Note to editor/reviewers. Plain text represents the original comment, and bold text represents the response.

Reviewer 1:

The paper presents a valuable exploration of the sources of error and potential improvements of common predictive methods for debris flow parameters. I have a few suggestions below:

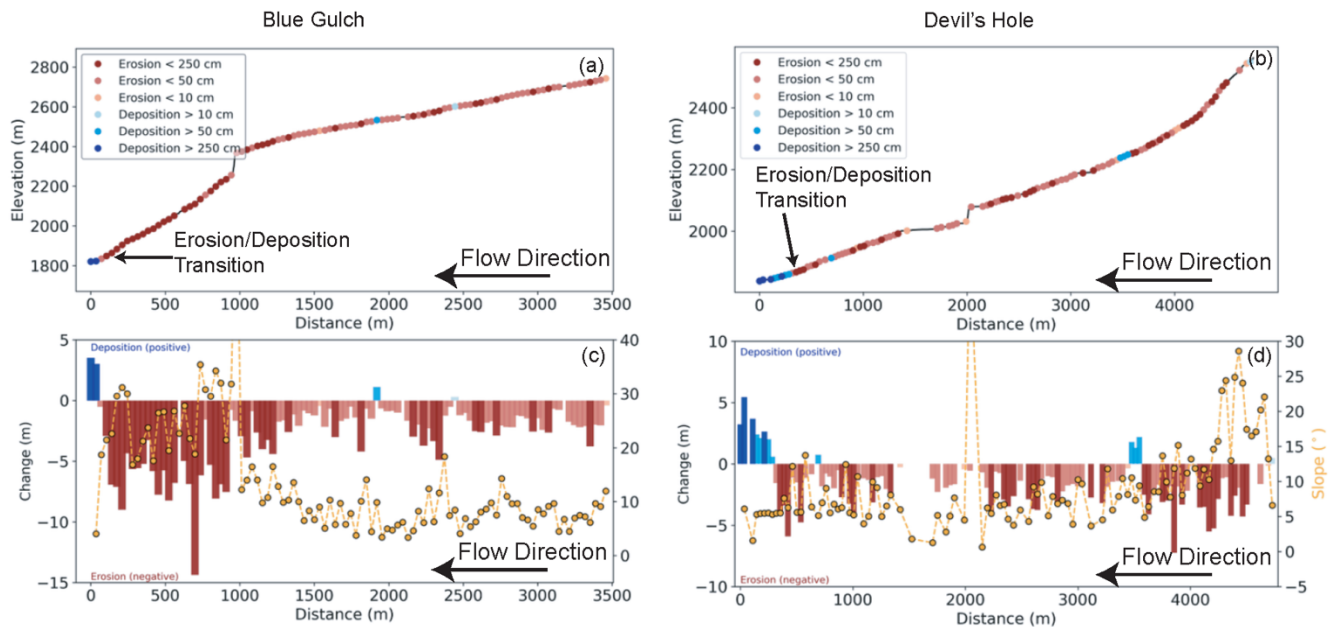
Figure 3 - isn't this backwards for (b)? Blue is deposition and red is erosion?

One thing that may be making this confusing is that I didn't indicate the flow direction. I have now done this on the figure. The colors in Figure 3b are correct. In figure 3b flow goes from ~4800 m to 0m (this is the outlet), as flow moves from the upper reaches you see lots of erosion (red). There is a little bit of deposition (blue) at a low sloping spot around 3500 m, but the channel is mostly erosional (red) until the slope flattens out around 500 m. This can also be visualized in figure 3d. But in both cases the blue color is equal to deposition, and we are showing that as a positive value. We also added this text to make it more clear:

"Using the two lidar datasets (1 m pixel), we subtracted the elevation of the post event lidar from the pre event lidar ($Z_{2021} - Z_{2016}$) to create a DoD map of erosion and deposition throughout the Grizzly Creek burn area (Figure 2 and Figure 3)."

Based on that method readers should be able to see that wherever the post event data is positive, it should be equal to deposition, and those values are shown in blue in the legend.

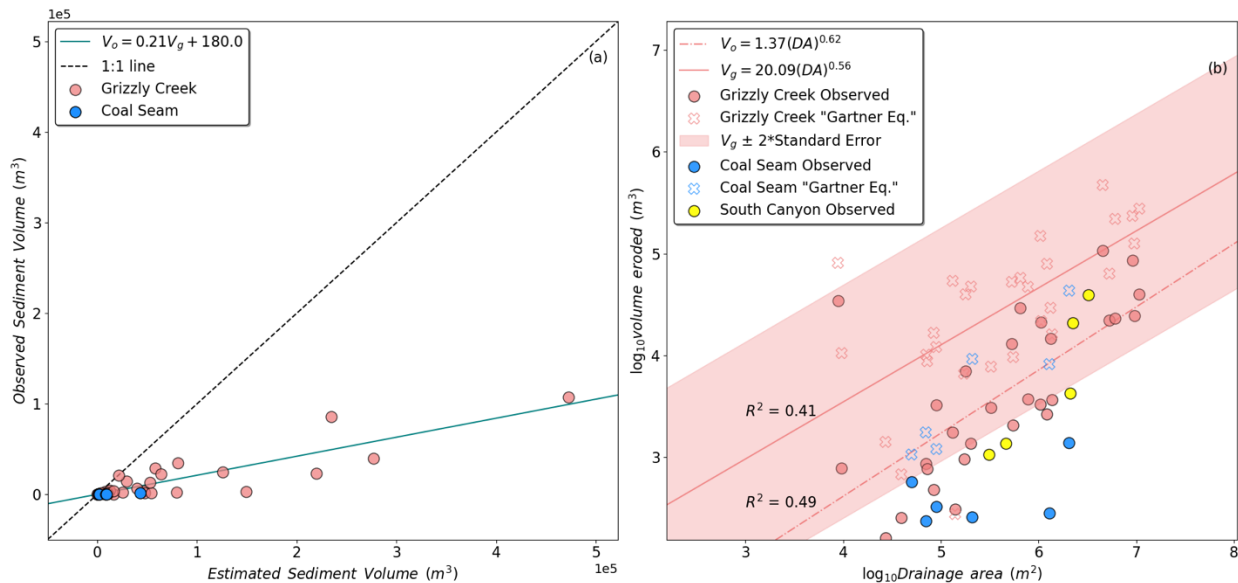
This leads to a bigger issue. The Gartner et al. and M1 models rely on a dataset with limited accuracy, but smoothed over an area and temporally. You are using more accurate data, which one would expect to produce better results, but in some ways compares apples to oranges. For instance, earlier volume prediction models relied on StatsGo or other generalized soil data for things like Liquid Limit. More accurate liquid limit measurements would not improve that model because they represent micro-data that is very different from the area-averaged data that the model used. The area-averaged data is not very good, but simply adding focused accurate data does not improve the roughness of the model. I want to make sure that your analysis does not fall in the same trap - providing more precision on a dataset that lacks in accuracy. I think it would help to comment on this disconnect.

The equation developed in Gartner et al., 2014 to predict postfire debris-flow volumes in the first year after fire was based on data that had considerable uncertainty. The methods that were used in that paper to obtain volume estimates were the following:

“Volumes of sediment removed from debris- retention basins were measured by counting the number of trucks filled during the cleanout of a debris-retention basin or by comparing field or aerial photographic surveys of full and empty debris-retention basins.”

The final multiple linear regression model, referred to as the “Emergency Assessment Model” in the Gartner et al., 2014 paper has a residual standard error of 1.04 (the equation predicts $\ln(\text{Volume})$ and

thus this value has no unit) and the Gartner et al. 2014 training data generally fit within bounds of one order of magnitude of the predictions. I think our data are likely more accurate and precise than this because I imagine that the uncertainty associated with counting trucks could be quite high. However, we don't have a good measure of the uncertainty from the approach used in Gartner et al., 2014. I don't think this impacts the results of this manuscript though. Functionally, the "Emergency Assessment Model" was developed to estimate volumes, and users take the volumes from that equation to make predictions. Although the data we are comparing may be higher precision and accuracy, I'm not sure that has any implications on the model. We are not trying to re-calibrate the model, and that is where I think we would fall into the trap that you point out. I think we would need more observations of volume across the Colorado region to attempt a model recalibration.

One addition that I have now made, is that I added a band of plus or minus 2*standard error, to Figure 9 for reference (see below) because 95% of the data should fit within this. Also, this is close to +/- one order of magnitude and the Emergency Assessment model observations fit within plus or minus one order of magnitude. So we now give readers a sense of the range that they should consider when looking at the volume estimates from Gartner et al., 2014.

Figure S1. Map showing initiation locations of debris flows with respect to rain gauges and verified debris-flow deposits.

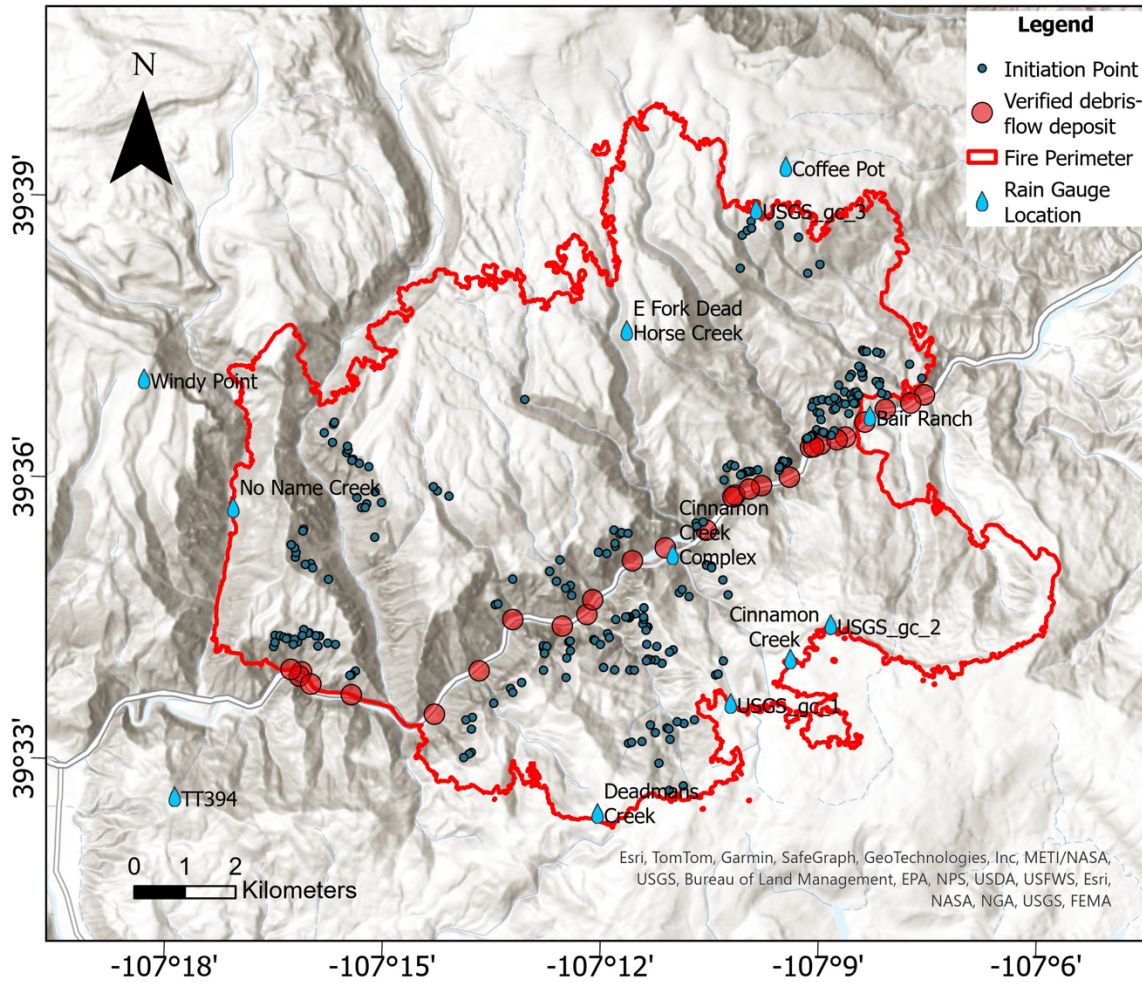
Line 195ff - even more important than the side of the canyon (north or south) and the proximity, is the elevation of the rain gauge, to account for orographic effects. Can you include a comment on this?

I agree that both elevation and the side of the canyon are important. Our mapping of debris-flow initiation showed that most of the debris flows started toward the canyon rim. In terms of elevation, this puts the initiation points closer to the elevation of the gauges, even if they are not as close distance-wise. Furthermore, due to the gage locations, we had to use the data available and didn't often have the luxury of choosing between both canyon side and gauge elevation. I made a map of the initiation points and the rain gauges that I have now added to the supplement.
